Memorandum

Project #: 58073.00

Re: Supplemental Materials in Response to Comments of the
Agency of Natural Resources Regarding Salisbury
AD 1, LLC Motion to Transfer and Amend CPG

Not Approved for Construction
Drawing Title:
**Wetland and
Wetland Buffer
Impacts Exhibit**

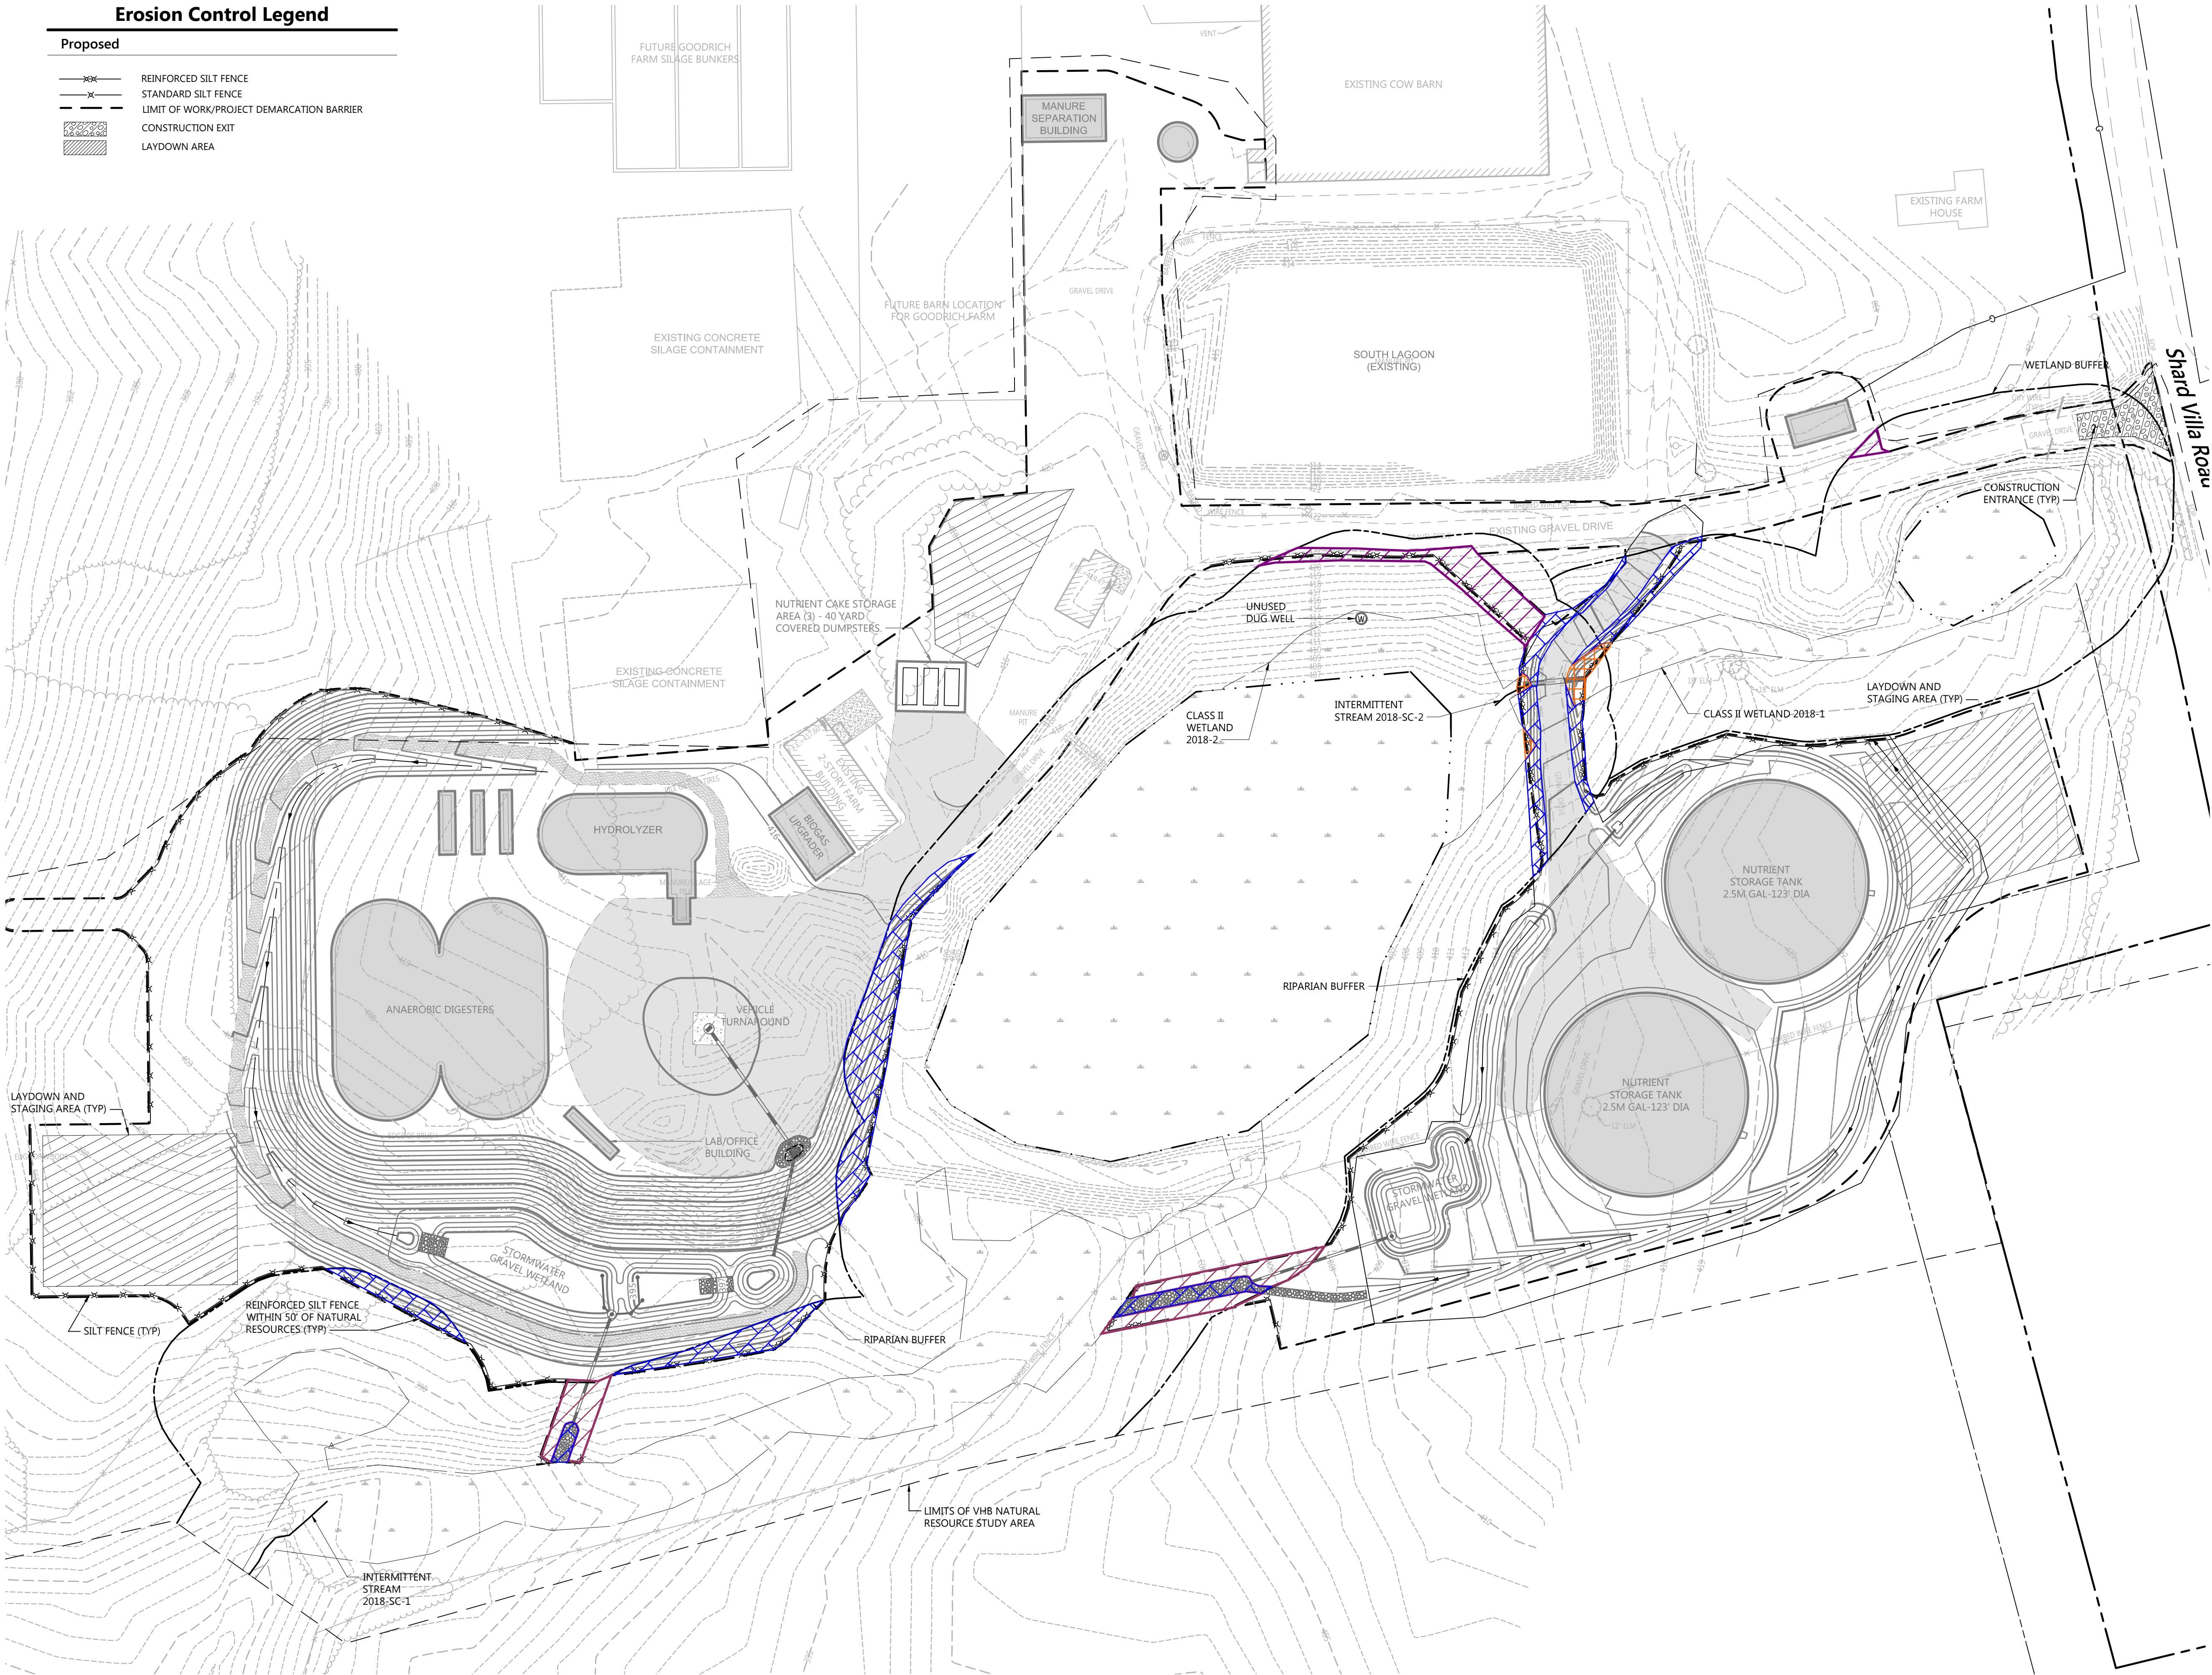
[C]omponents of the Amended Project which will receive, transport or contain waste (feedstock or digestate) are located in close proximity to wetlands. However, there are a lack of details concerning prevention of waste from entering wetlands as discussed above. The conceptual site plan (Exhibit SAD1-3) reveals that the Amended Project proposes disturbance within wetlands and / or wetland buffers. However, the amount of disturbance is not quantified and the way in which the wetlands or buffers will be disturbed and otherwise impacted by the construction and operation of the Amended Project's infrastructure (e.g., piping, stormwater structures, etc.) is not described or explained.

Grading for the Project's vehicle access area and stormwater infrastructure will require some minimal disturbance to the wetland and wetland buffer. In addition, the culvert under the access road to the NSTs will need to be replaced and the road widened to accommodate tanker trucks, which would result in minor direct permanent impacts to the wetland and intermittent stream. Currently, the channel has no connectivity to up- or downstream channels, as intervening wetlands are not the type that are saturated year-round. The channel segment itself is artificially manipulated and subject to intermittent flows. The Project proposes to replace the existing 18"-diameter corrugated metal culvert with a new 36"-diameter HDPE culvert that will be partially buried and backfilled with streambed substrate to improve hydraulic connectivity between portions of the wetland on either side.

The anticipated impacts to the wetland, buffer, and intermittent stream are depicted on the attached Wetland Impact Plan. In summary, approximately 10,325 sq. ft. of permanent wetland buffer impacts, 5,590 sq. ft. of temporary wetland buffer impacts, and 560 sq. ft. of wetland impacts are anticipated, for which Salisbury AD 1 will seek authorization under the Vermont Wetland General Permit. The direct wetland and stream impacts are expected to be authorized under the Army Corps of Engineers Section 404 General Permit ("404 Permit") via Pre-Construction Notification of the Vermont General Permit. The Project has been designed to first avoid, and then minimize, wetland and Class II buffer impacts to the greatest extent feasible while still achieving the Project's purpose and need. Proposed wetland and buffer impacts would occur in resource areas which already have been previously impacted by activities at the farmstead, invasive

-  Permanent Buffer
10,325 Square Feet
-  Permanent Wetland
560 Square Feet
-  Temporary Buffer
5,590 Square Feet
